UNITED STATES
NUCLEAR REGULATORY COMMISSION
WASHINGTON, D. C. 20555

The Commission has issued the enclosed Amendments Nos. 111 , 111 , and 108 for Licenses Nos. DPR-38, DPR-47 and DPR-55 for the Oconee Nuclear Station, Units Nos. 1, 2 and 3. These amendments consist of changes to the Station's common Technical Specifications (TSs) in response to your request dated November 13, 1981, as supplemented by letter dated March 24, 1982.

These amendments revise the TSs to support full power operation of Oconee Unit 2 during fuel Cycle 6.

SAFETY EVALUATION BY THE OFFICE OF NUCLEAR REACTOR REGULATION

CORE PROTECTION SAFETY LIMITS
UNIT 2
OCONEE NUCLEAR STATION
FIGURE 2.1-2B

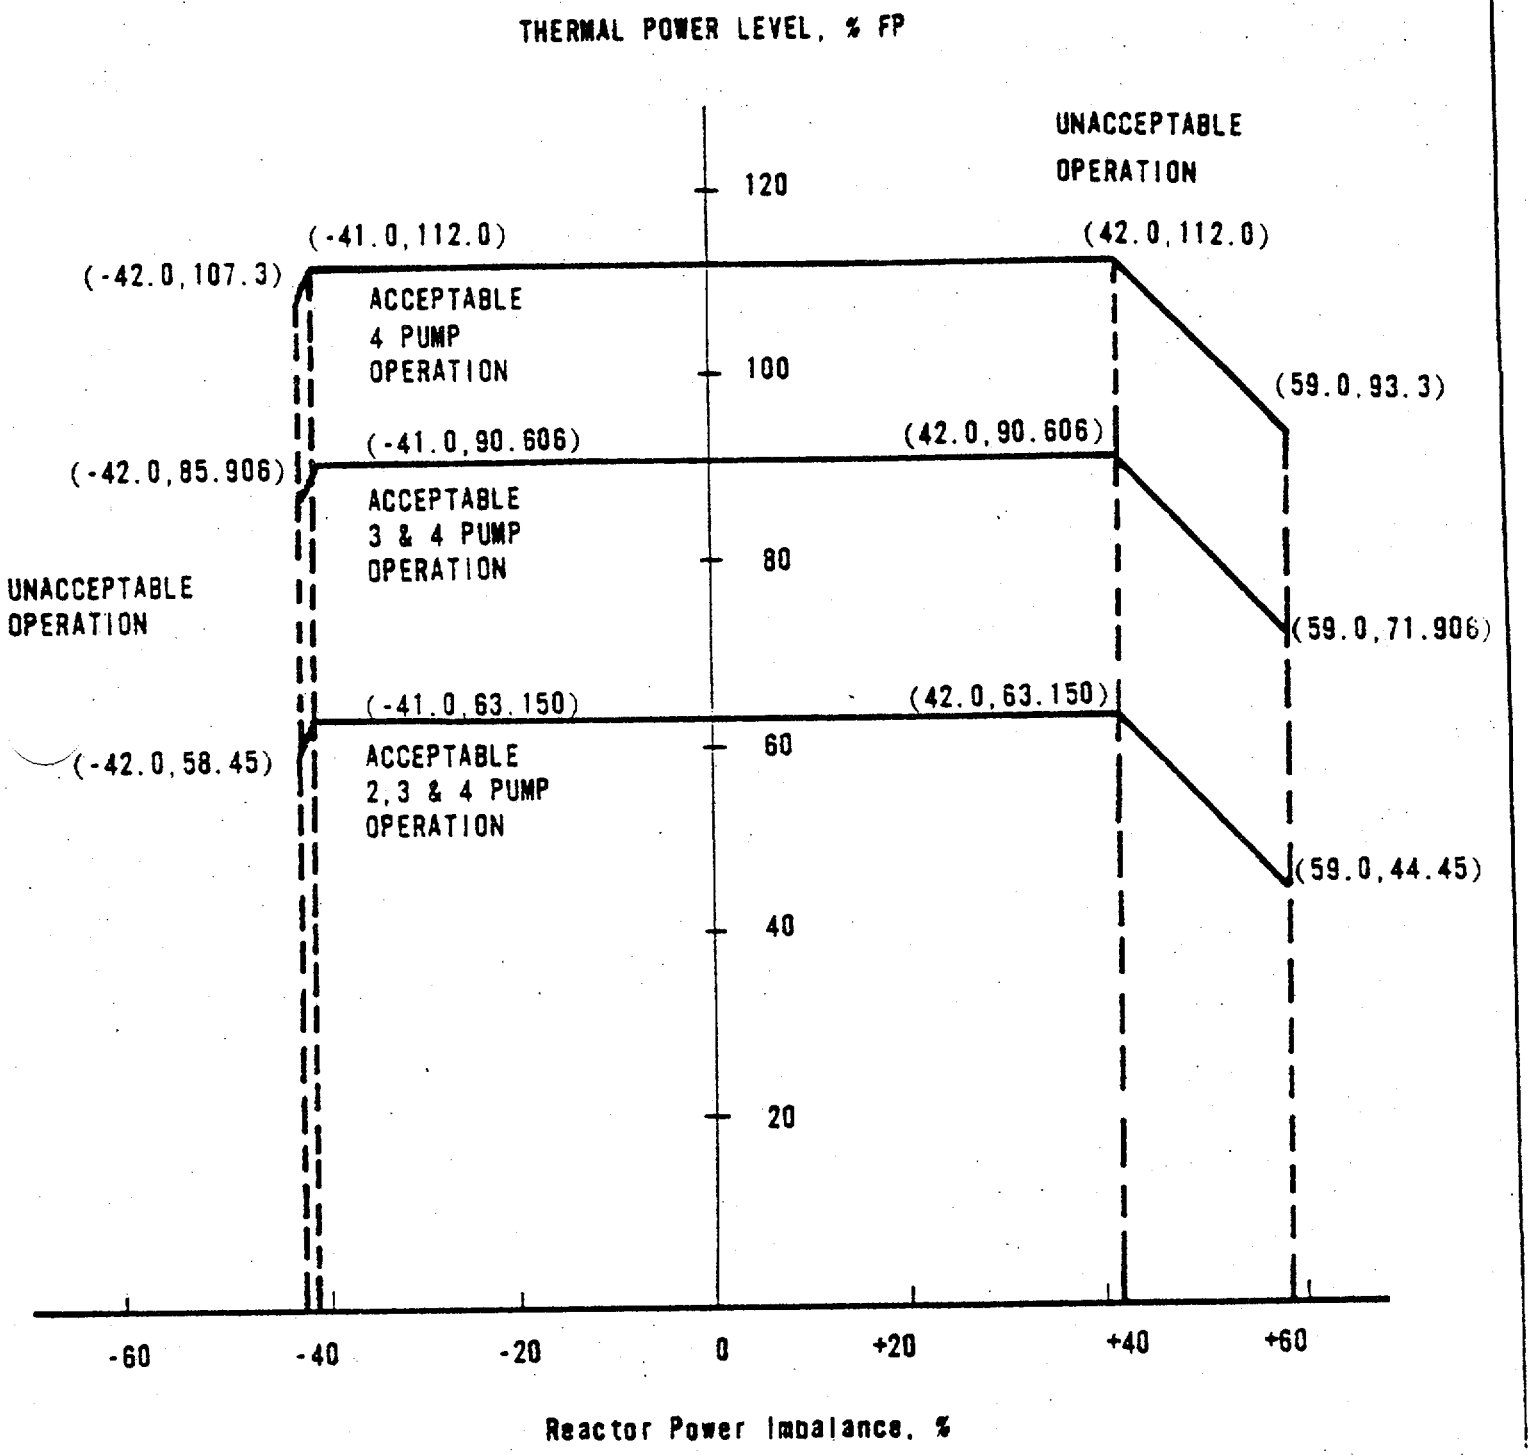
To support the operation of Oconee 2 at full power during Cycle 6, the licensee proposed modifications to core protection safety limits of TS 2.1 (Figures 2.1-2B, 2.1-3B and 2.3-2B). The changes reflect a revised flux/flow setpoint of 1.08 which remains within the safety limit DNBR criterion of 1.30 and is, therefore, acceptable.

The specified flow rates for Curves 1, 2, and 3 of Figure 2.1-2B correspond to the expected minimum flow rates with four pumps, three pumps, and one pump in each loop, respectively.

PROTECTIVE SYSTEM
MAXIMUM ALLOWABLE SETPOINTS
UNIT 2
OCONEE NUCLEAR STATION
FIGURE 2.3-2B

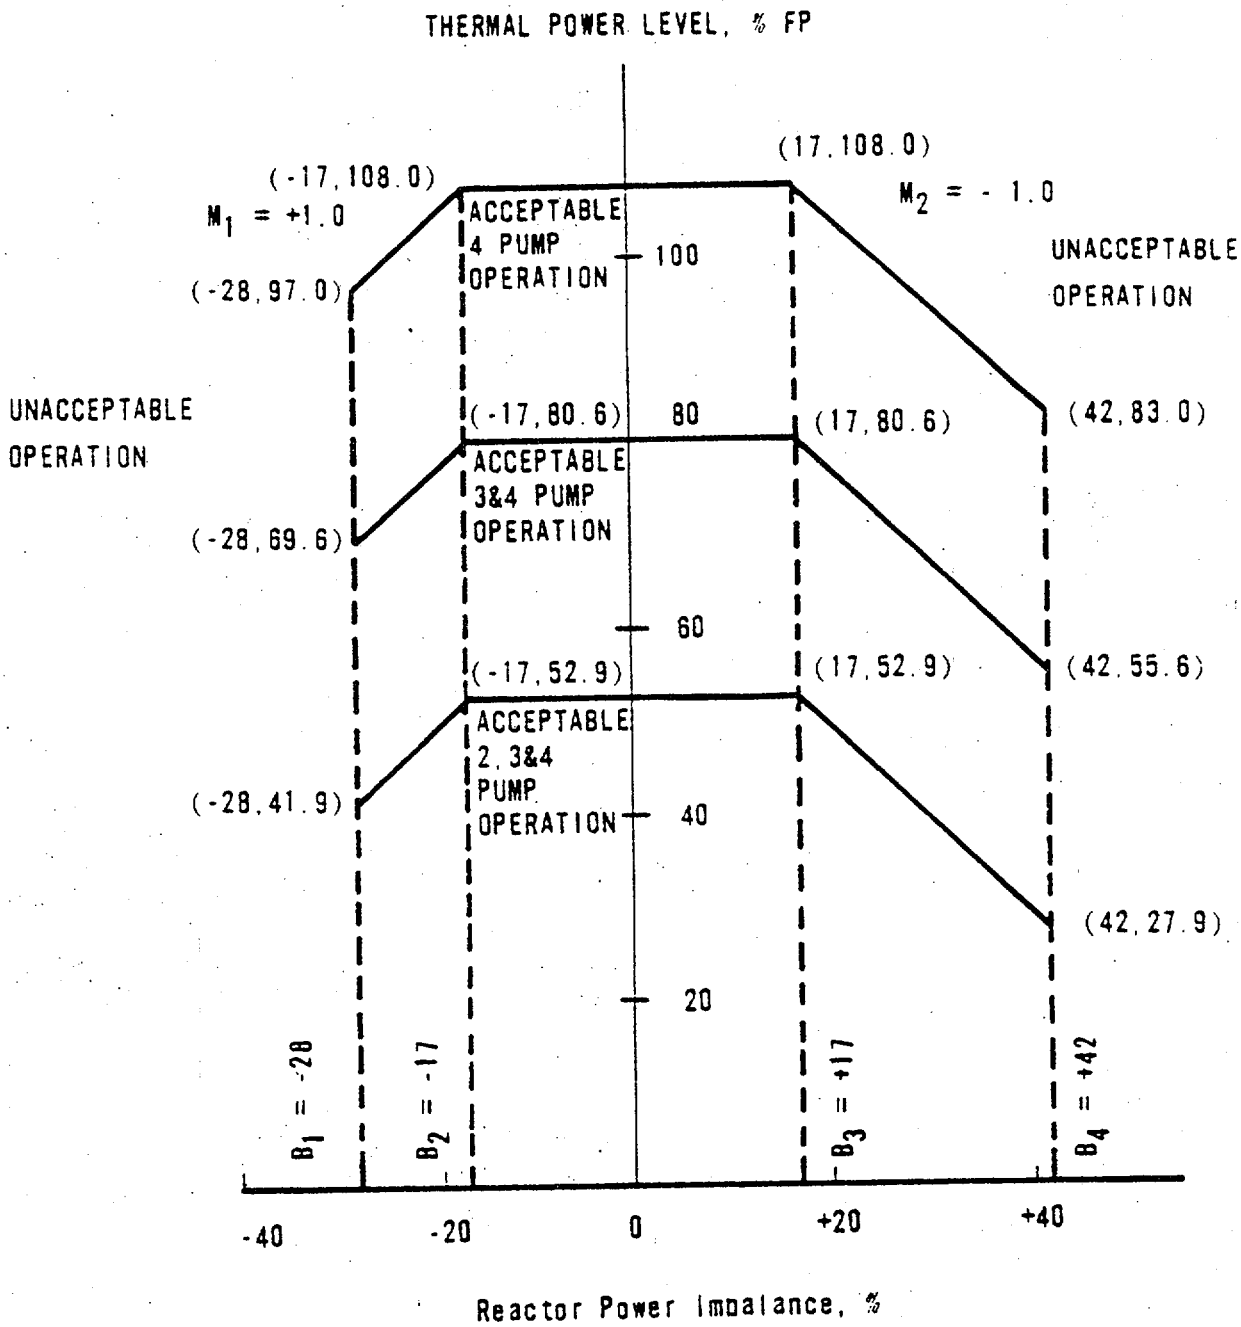
The effects of the recently discovered under-estimate of the errors in certain modules of the reactor protection system have been included. The nuclear overpower trip setpoint was reduced from 105.5 to 104.9 percent full power, and the high reactor coolant temperature trip was reduced from 619 to 618 degrees Fahrenheit. On the basis that these setpoints were established by previously accepted methods, we conclude that the revised limits are acceptable.
